RESPONSE TO Z-8945

Near Campus Designation

Proposed Development Envelope

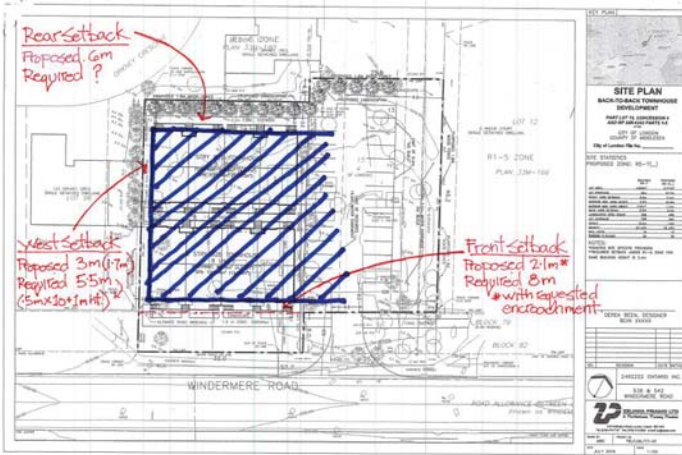
Food for Thought: 60 bedrooms / .277ha = 216 Br/ha

Excerpt of email from Leif Maitland to Melissa Campbell
Sept. 20/18

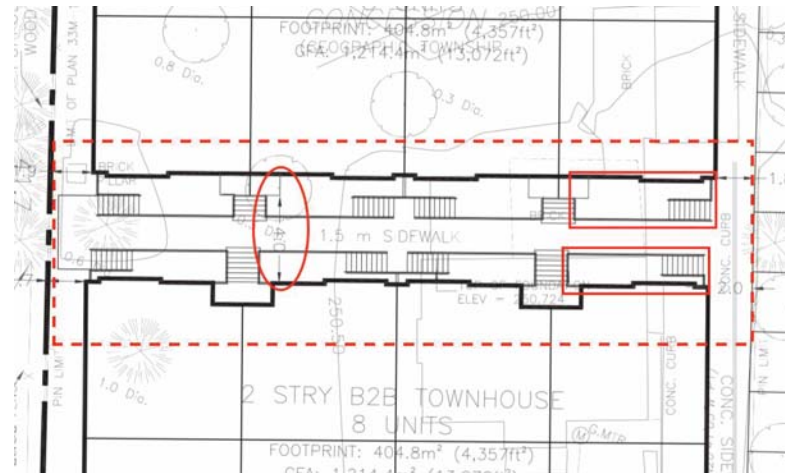
- o A 1.7m setback, as requested, does not provide adequate space to provide for the landscaping and screening required under the Site Plan Control By-law. This requested setback is of particular concern as the need for screening is more pronounced in infill developments like the one proposed. Maintaining the buffer of mature trees as requested at Site Plan Consultation cannot be achieved by intruding to the proposed extent into the standard setback and removing those trees, both of which would be the case should the site plan be developed as proposed. Trees currently along the property line, require space to remain healthy long term.
